THE PORT AUTHORITY OF NY & NJ

ADDENDUM #2

**TO PROSPECTIVE BIDDER(S) ON CONTRACT # WTCR – W30-2011-31
WTC REDEVELOPMENT – WTC TOWER 2 PLAZA INTERIM IMPROVEMENTS**

SK-1
MPFP
2-10-15

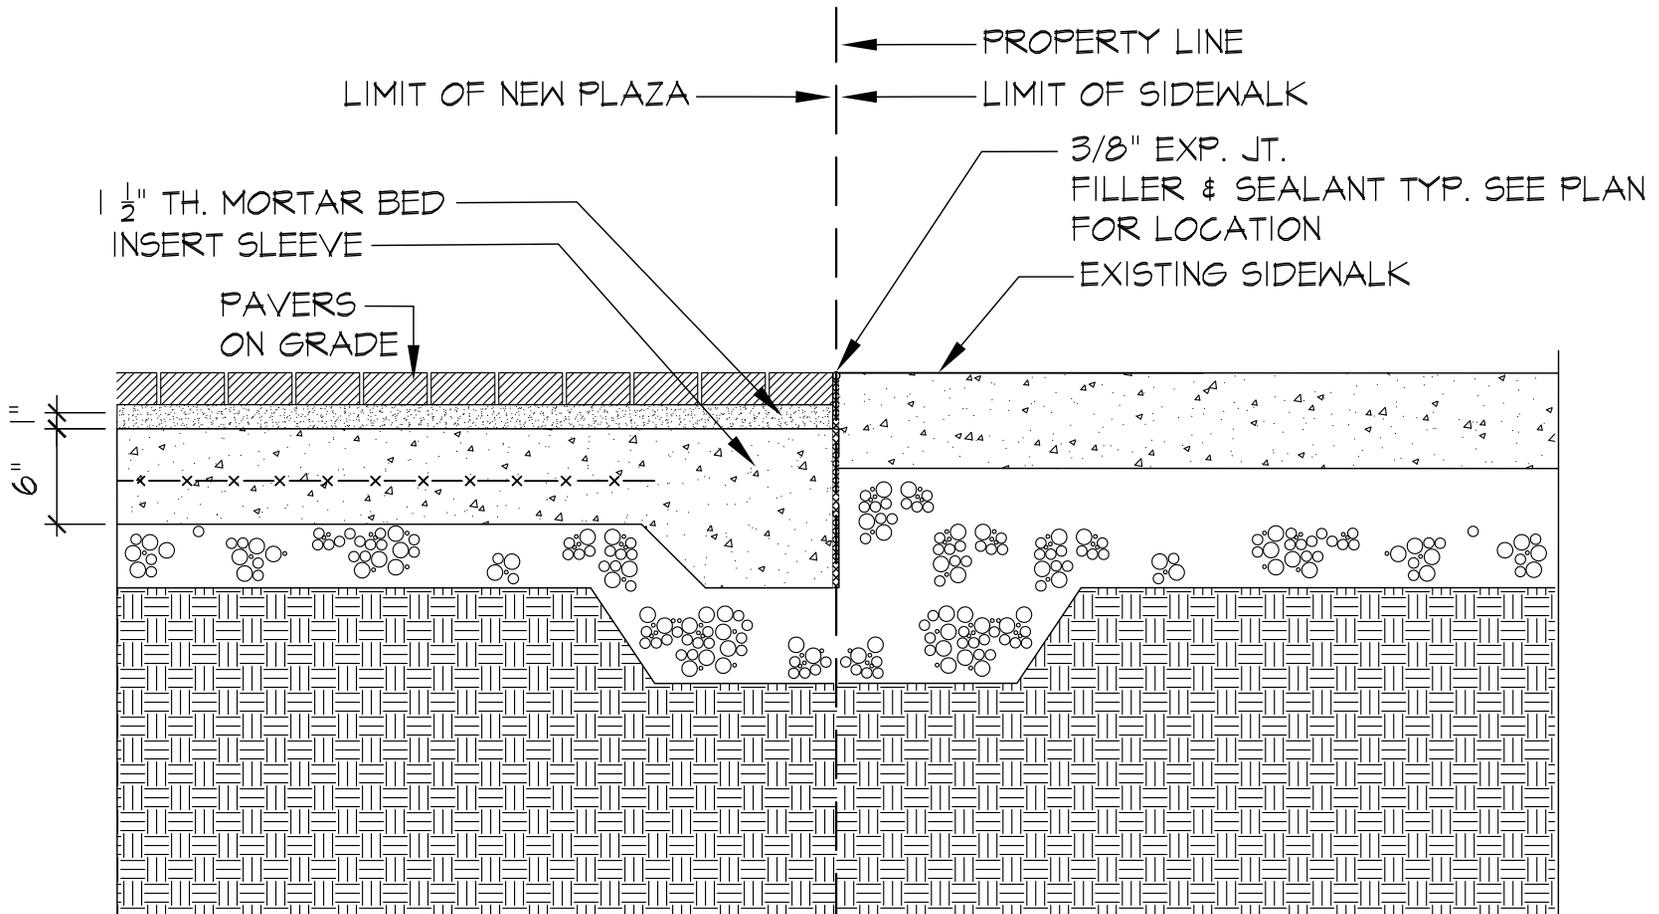
Question #31	Sheet L-100 – Please provide details at the property line that shows how the new work will tie into the adjacent paving areas.
Answer #31	Refer to attached sketch - SK-1, dated 02/10/15.

NOTE: FOR PAVING DETAILS
REFER TO L-600. SKETCH IF FOR
CLARIFICATION PURPOSES ONLY

SK-2
SCALE: 1/8" = 1'-0"
MPFP
2-10-15

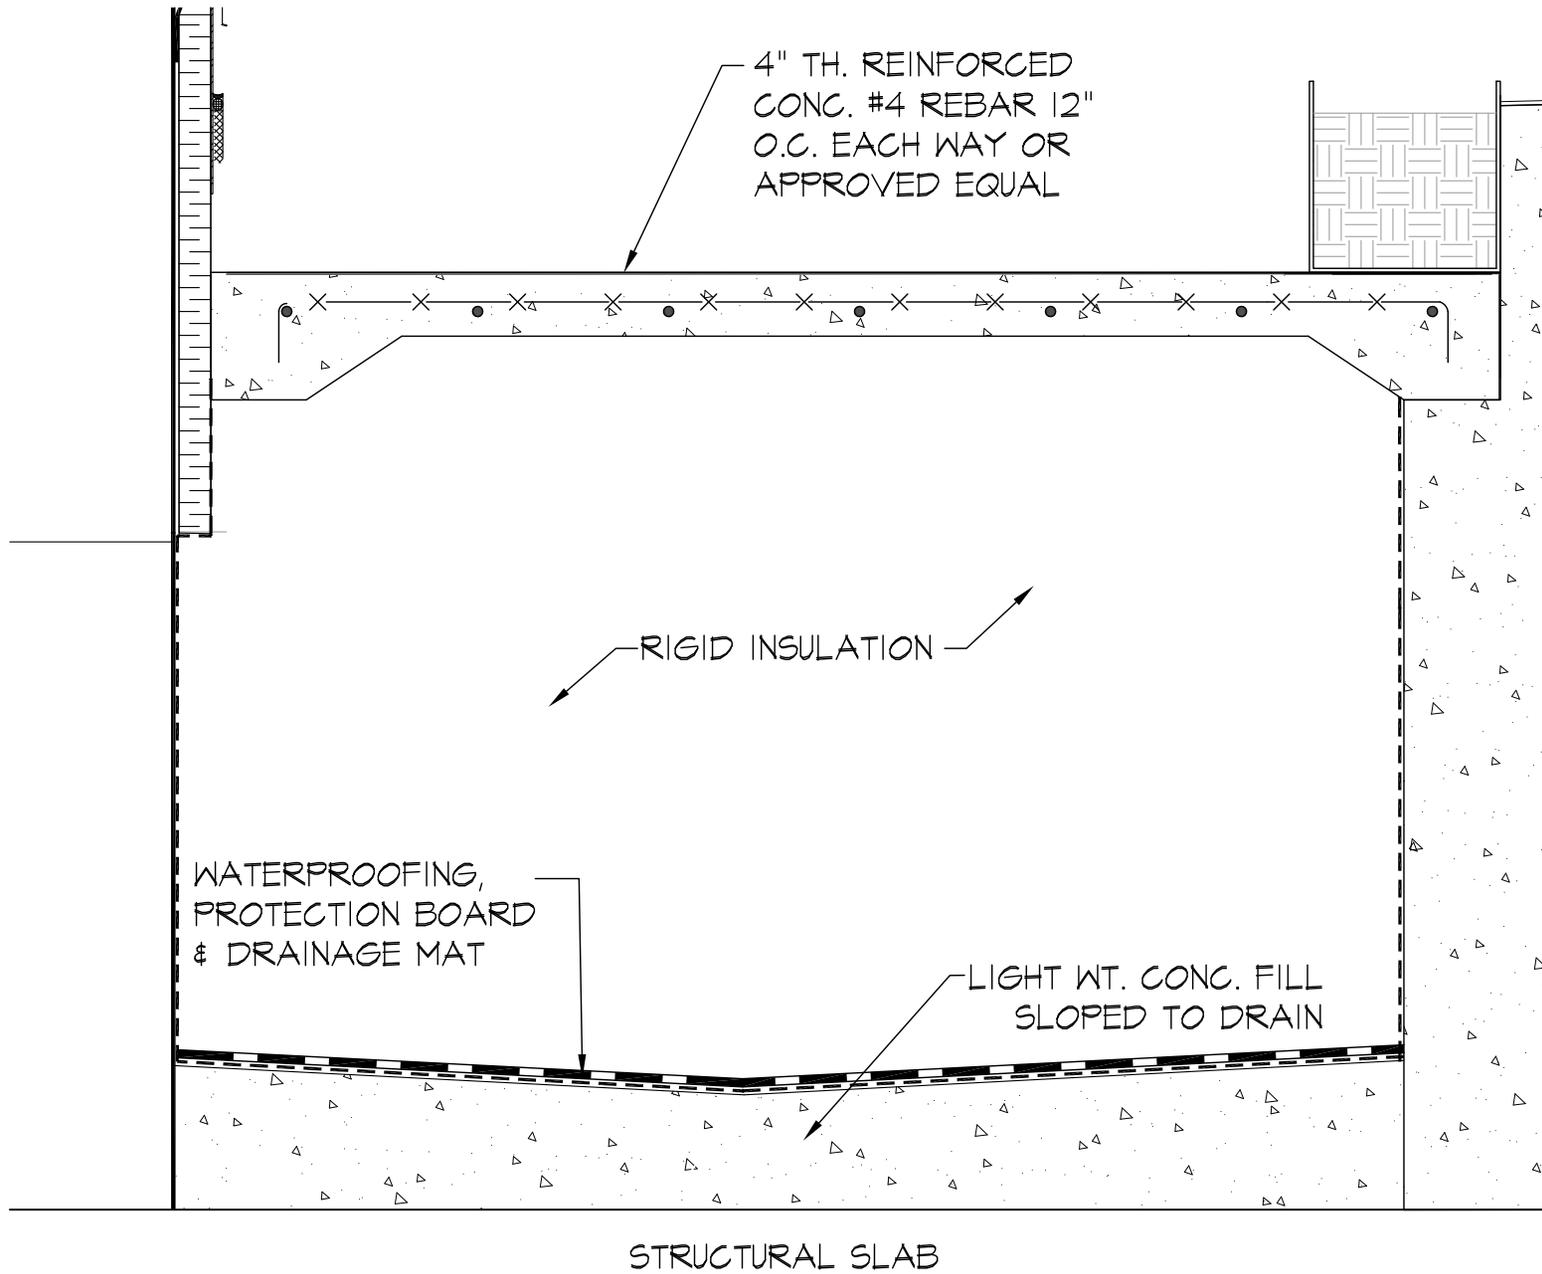
Question #46	Drawing L-600, upper left side 2 BENCH DETAIL shows the Proposed Concrete Bench Plinth dimensioned 4'-6" wide. There appears to be a thickened edge of a concrete slab resting on the left side of it. The Concrete Slab continues to the left. The Fiberglass Planter is shown resting on the Concrete Slab in question. This Concrete Slab shows up again in 4 DOUBLE BODY PLAZA DRAIN show as connecting to the face of the building. The Concrete Slab shows up in 9 TILE SET HATCH DETAIL. We cannot find any information about this Concrete Slab on the Structural Drawings. However it shows up on Dwg L-500 in 1 SITE SECTION on the left end. Please provide more information about this Concrete Slab i.e. thickness, reinforcement, how it attaches to the face of the building, and whatever else you can provide to us.

Answer #47	Yes.
Question #48	Drawing L-600 at 5 SIDE OUTLET PLAZA DRAIN, shows the drain and shows "FINISHED PAVEMENT FOR PAVING MATERIAL SEE PAVING PLAN." The Dwg L-101 PAVING PLAN offers no information about the thickness nor the material of the 'pavement.' Please advise.

Answer #46	This area shall be concrete paving; refer to SK-2 and SK-2A, dated 2/10/15, attached for details.
Question #47	Drawing L-100, shows the legend for PLAZA DRAIN - LD1 and PLAZA DRAIN - LD2. The 1 KEY AND DIMENSION PLAN indicates 1 (one) PLAZA DRAIN - LD1 and 2 (two) PLAZA DRAIN - LD2. Dwg L-101 shows the same. Dwgs L-102 & L-103 show the same, Dwg L-200 shows the same. Dwg L-600 at 4 DOUBLE BODY PLAZA DRAIN is identified as AD1 and at 5 SIDE OUTLET PLAZA DRAIN is identified as AD2. We have interpreted that these AD1 & AD2 are the same as LD1 & LD2; would that be correct?

Answer #48	This area shall be concrete paving; refer to SK-2 and SK-2A, dated 2/10/15, attached.
Question #49	Spec 220002 PLUMBING UNIT PRICES seems to be a vestige remaining from a previous larger and more comprehensive project. Is it safe to assume that these unit prices may be ignored for WTCR-W30-2011-13?

SK-3
SCALE: 3" = 1'-0"
MPFP
2-10-15

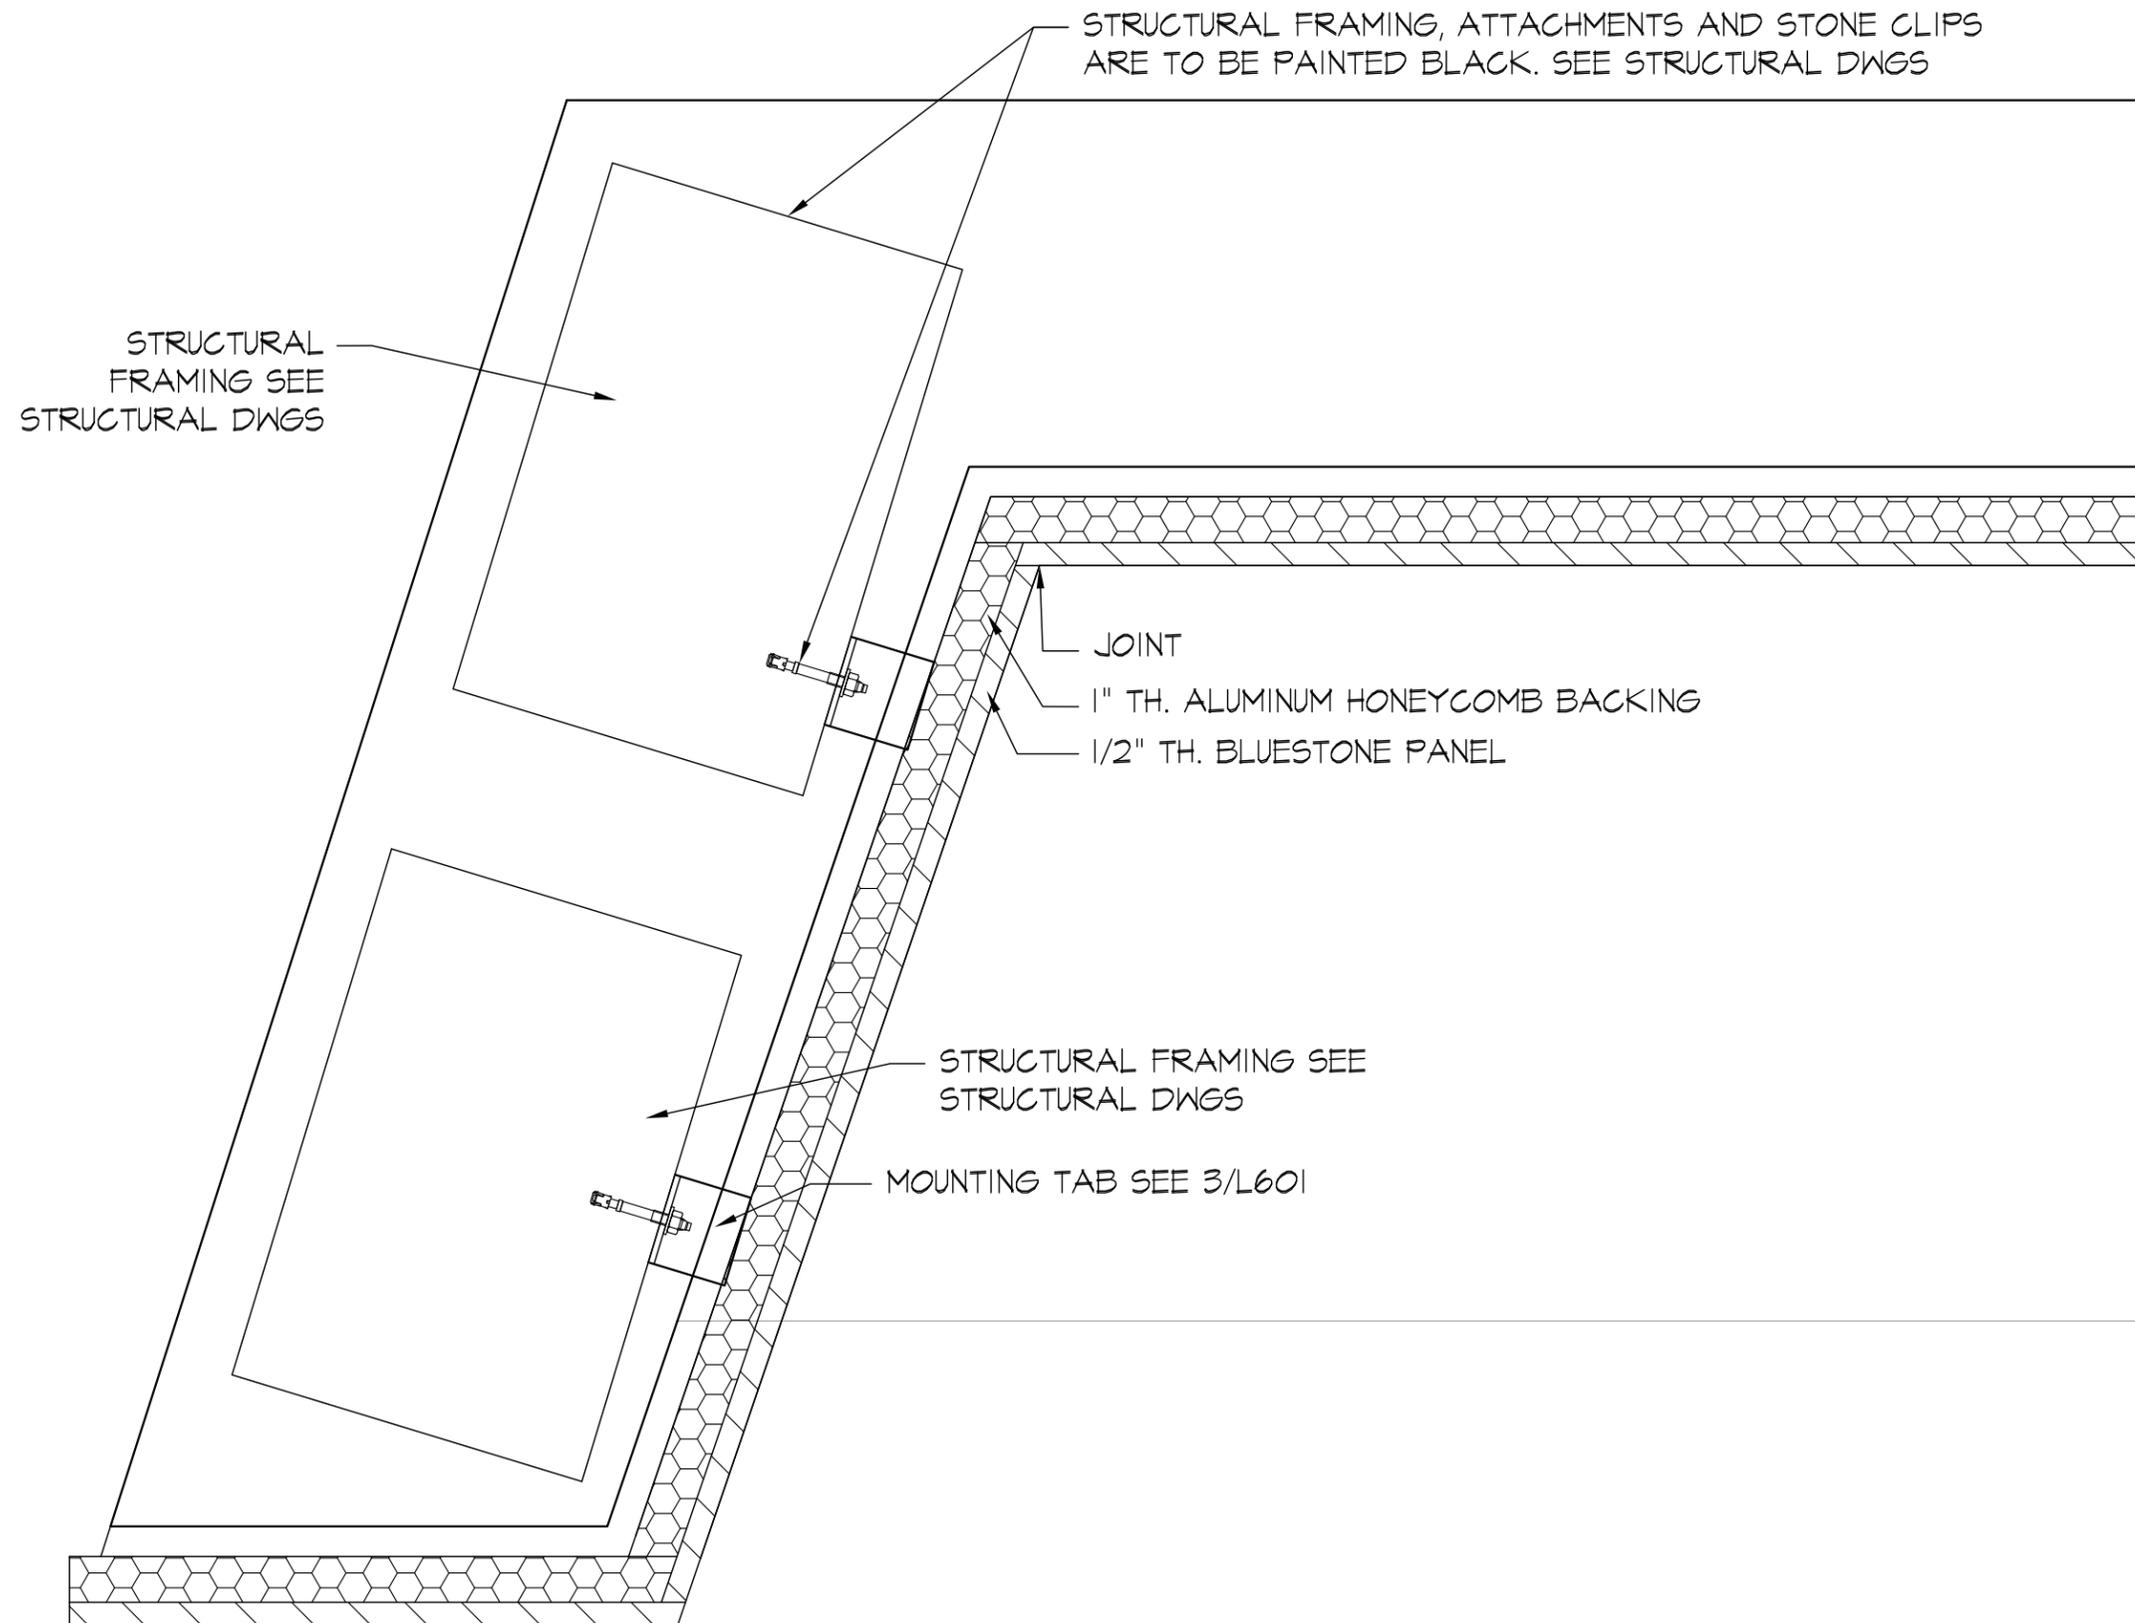
Answer #50	Yes.
Question #51	Drawing L-104 at 3 TYPICAL ELECTRICAL ACCESS BOX DETAIL calls for "ACUDOR PRODUCTS INC MODEL #FB-5060-TD. Our research indicates this access box cover is for interior walls (see attached data sheets). It does not seem appropriate for an exterior plaza floor. Please advise.

Answer #51	Substitute with FT-8050 24"x24" as shown on the attached Sketch SK-3, dated 2/10/15.
Question #52	L-302 – Please provide a plan and detail showing the irrigation lines to the tree planters.

SK-4
 SCALE: 3" = 1'-0"
 MPFP
 2-10-15

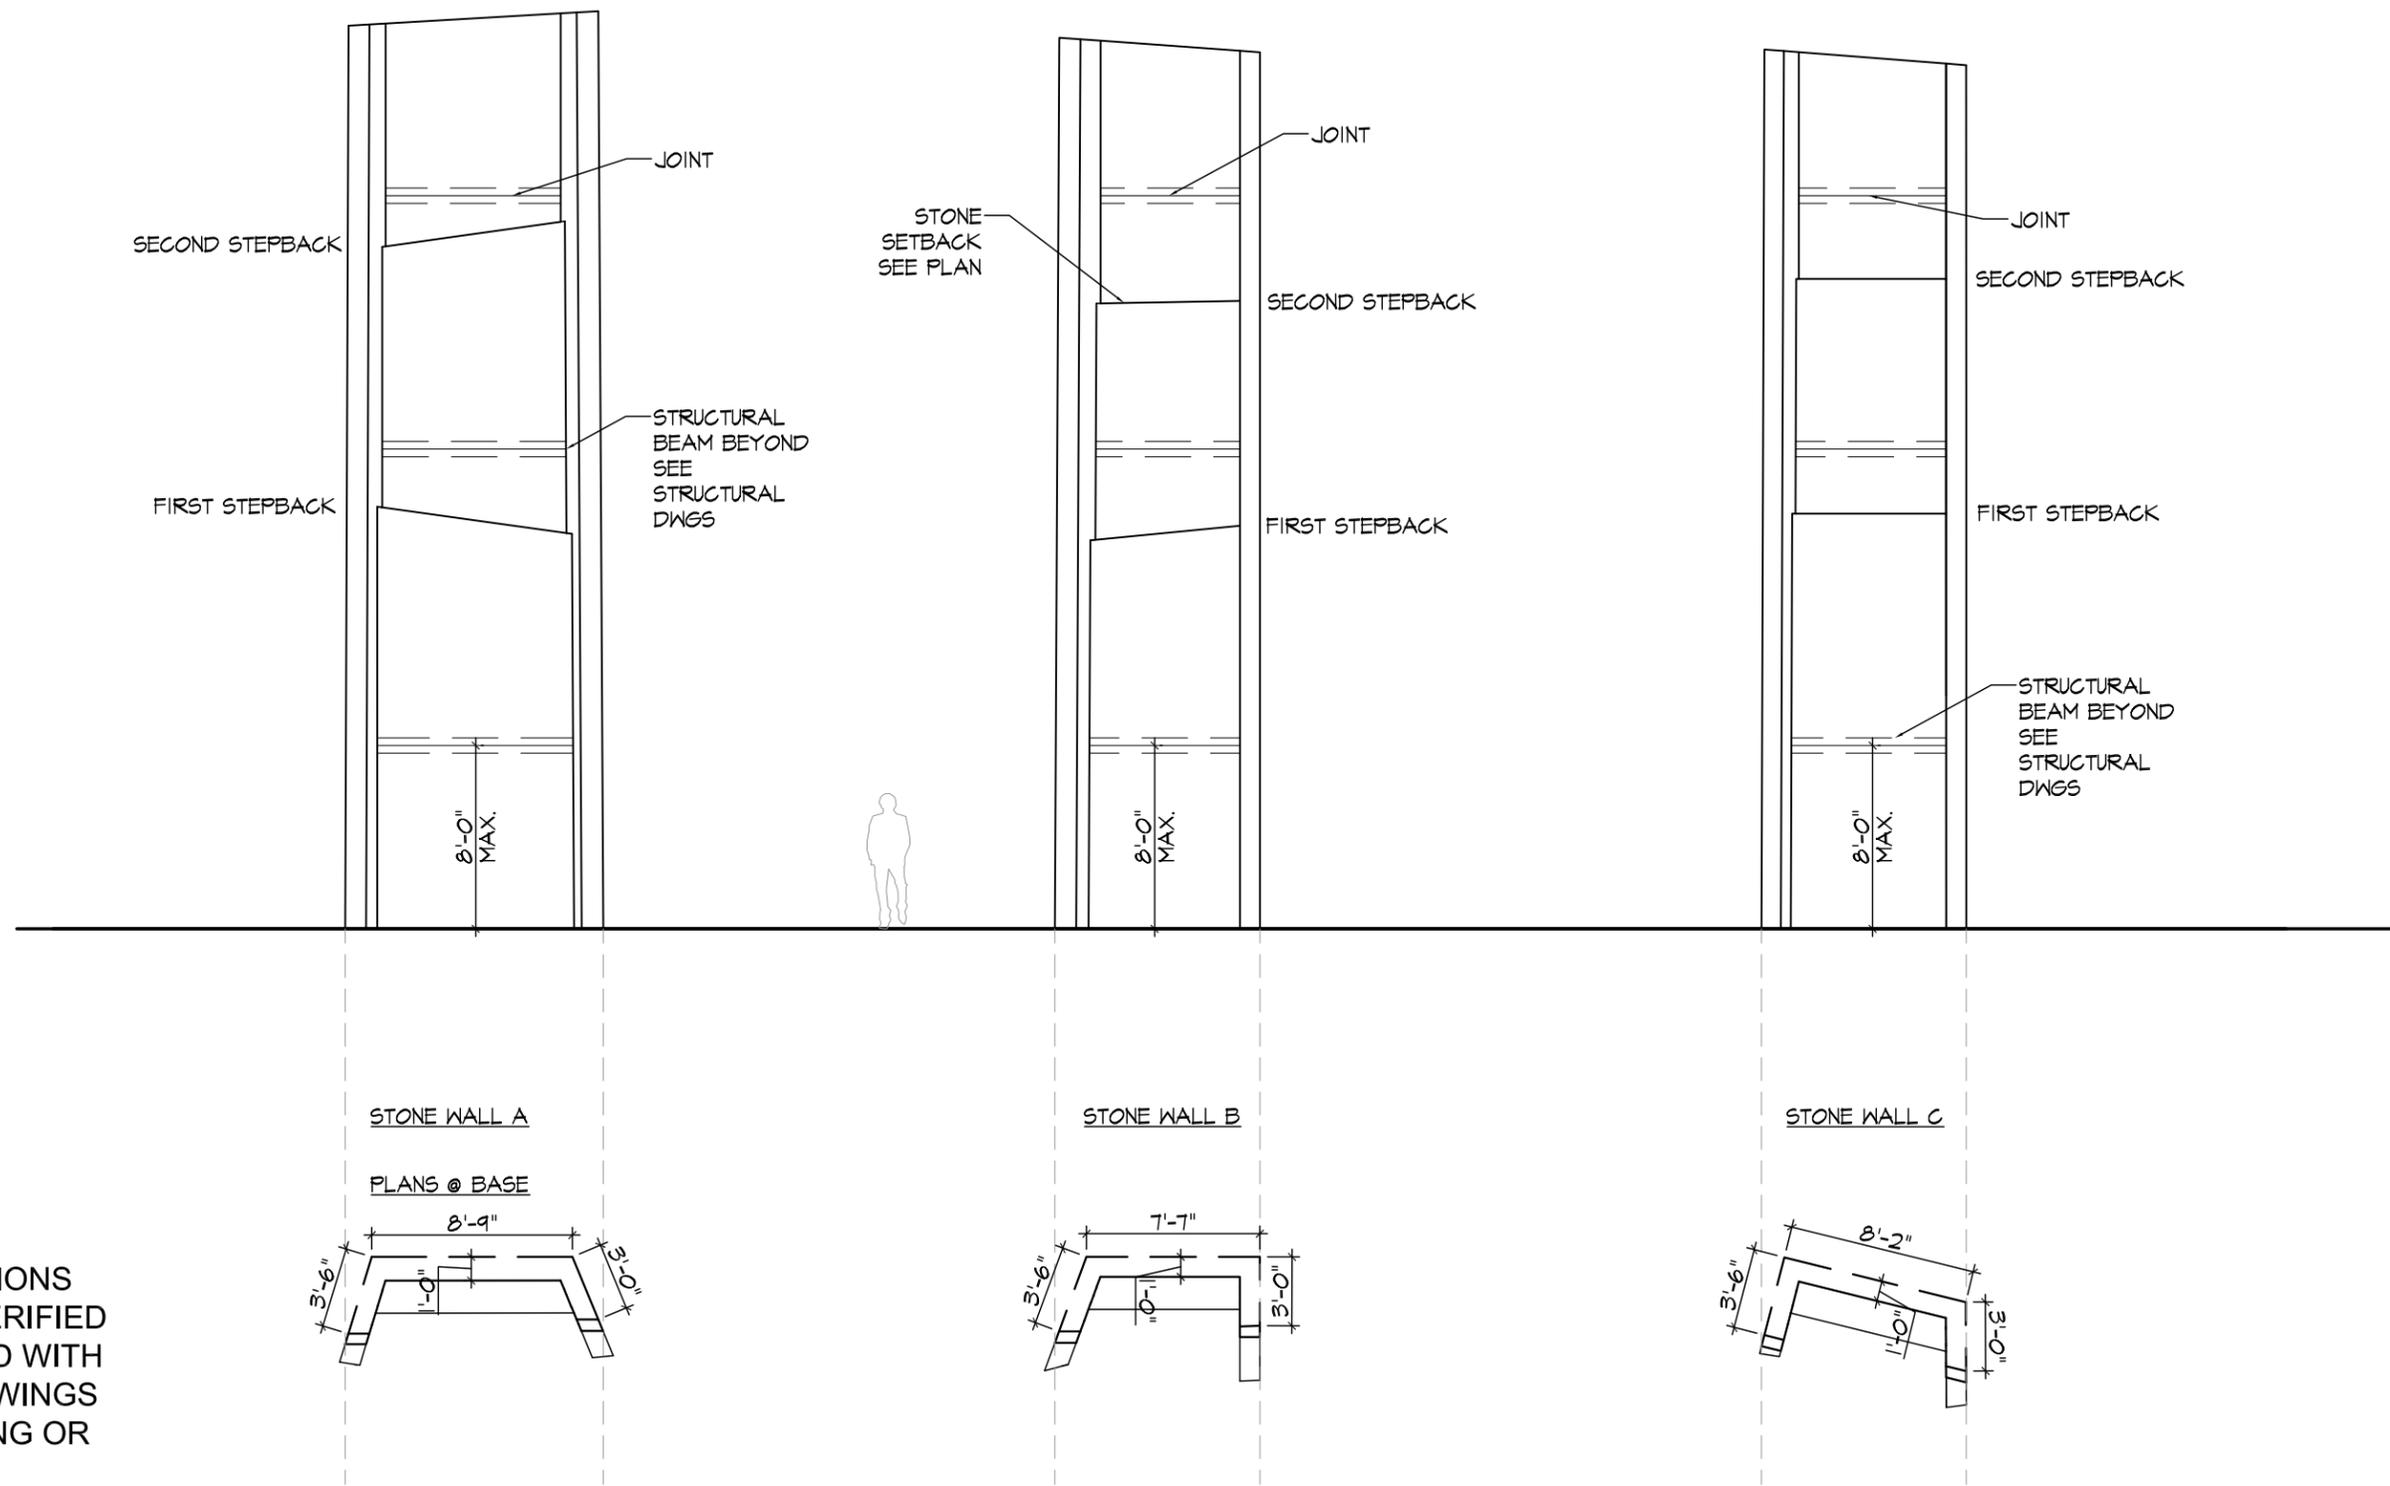
Question #32	Sheet L-601 – Note states: "Dashed lines represents faces to be clad in marine grade plywood..." Please provide dimensions from face of structure showing how far stone extends back (if any).

Answer #32	Refer to attached sketch - SK-5, dated 02/10/15 which provides additional dimensions. Furthermore, refer to sketch - SK-4, dated 02/10/15 for details regarding typical layout and extents of the stone panels. Please disregard marine grade plywood, it is no longer part of the contract. Backs of the stone panels to be painted black instead.
